Document Type/Title: La Costa Town Square Draft EIR

**SUBJECT: DENIAL OF WATER QUALITY CERTIFICATION
LA COSTA TOWN SQUARE PROJECT
APPLICATION 09C-043**

SUBJECT: La Costa Town Square, Carlsbad, San Diego County, CA

LA COSTA TOWN CENTER
 Jurisdictional Delineation Map

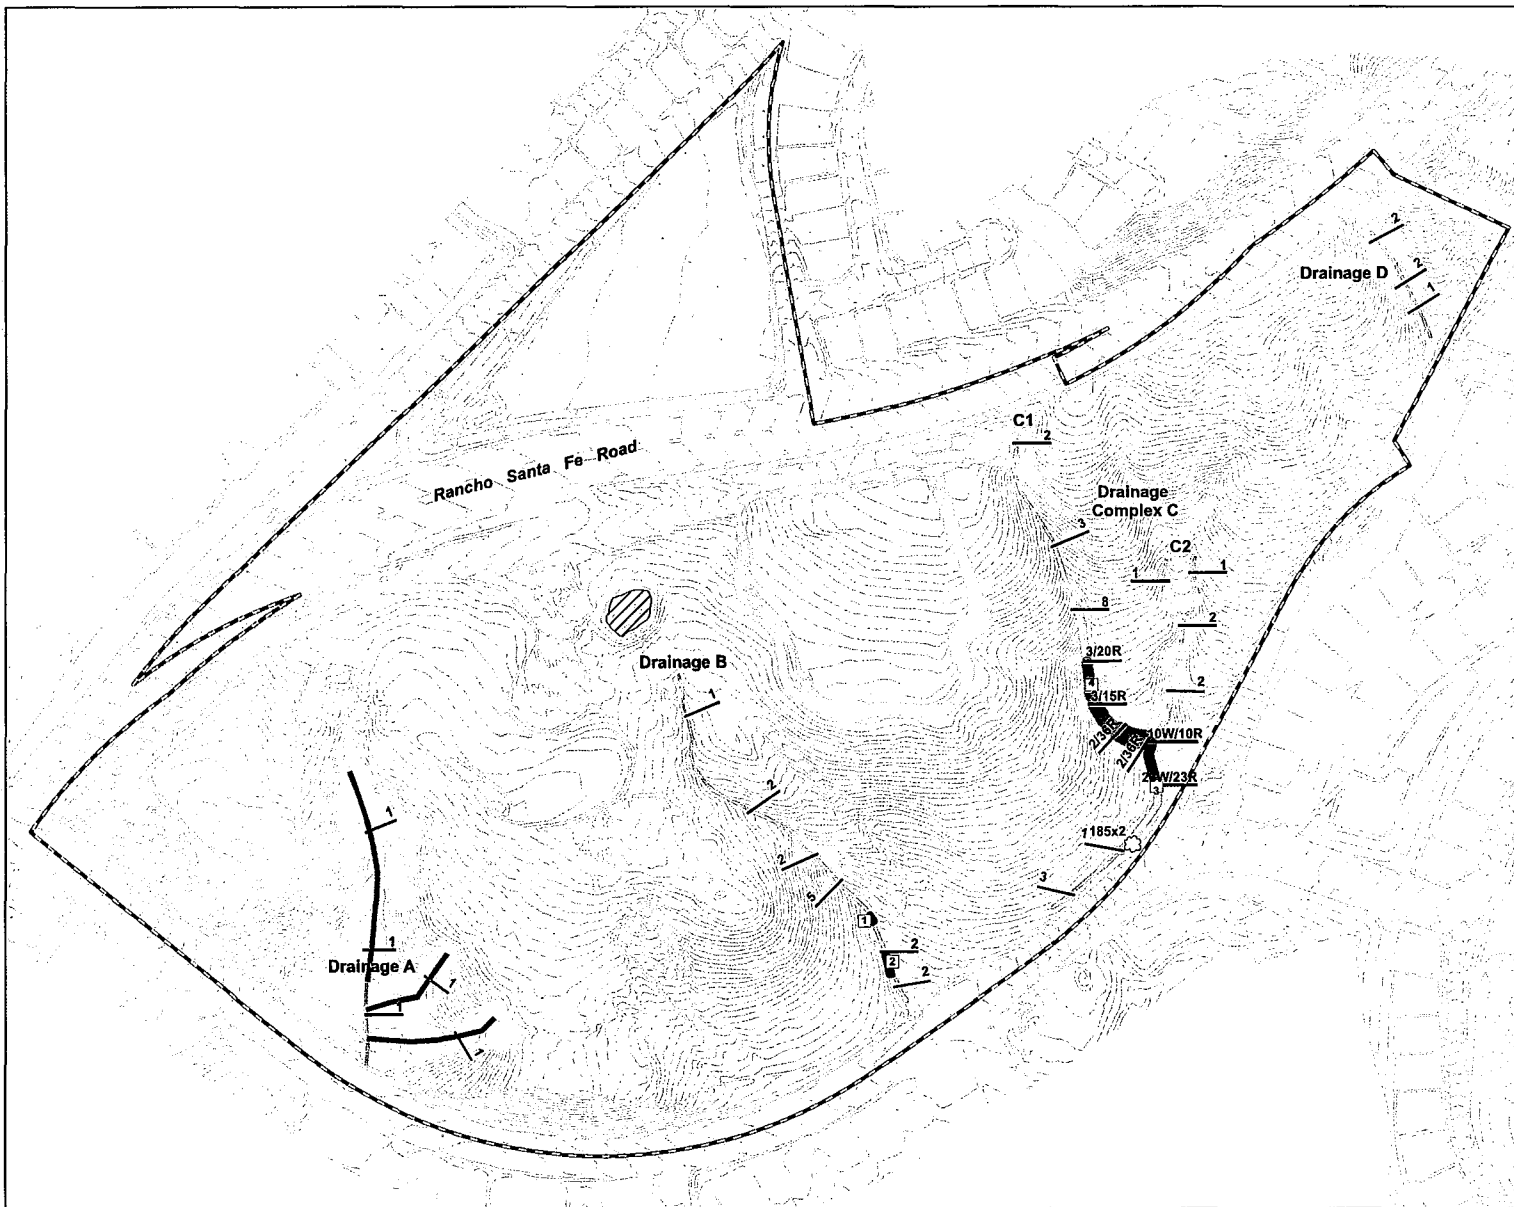
It does not appear that the applicant has attempted to avoid impacts Waters of the U.S. and State. Is that the case?

It does not appear that applicant has attempted to minimize impacts to Waters of the U.S. and State. Is that also the case?

Proposed mitigation is the purchase (1.26-acres) of wetland mitigation credits (0.41-acre was deducted) from the North County Habitat Bank. The impacts are mostly to upland, ephemeral streams (3) totaling 3981-ft. The proposed mitigation is out-of-kind. Under Porter-Cologne, we are charged with protecting the chemical, biologic, and **physical** integrity of Waters of the State. A polygon of Southern willow scrub does not adequately mitigate for the chemical and physical impacts to nearly 3/4 of a mile of three streambeds. Is there any way that these streams can be re-created onsite or nearby? Developers in Region 9 have been re-creating streams onsite for mitigation.

As you mentioned in your letter of June 9th, the project does not avoid impacts to waters of the U. S. We did attempt to avoid and if possible minimize, however, the project could not be accomplished in another fashion given the topography of the parcel. Therefore, once you review the table from Page 3 of the cover letter with the attached exhibit you will be able to identify the impacts clearly.
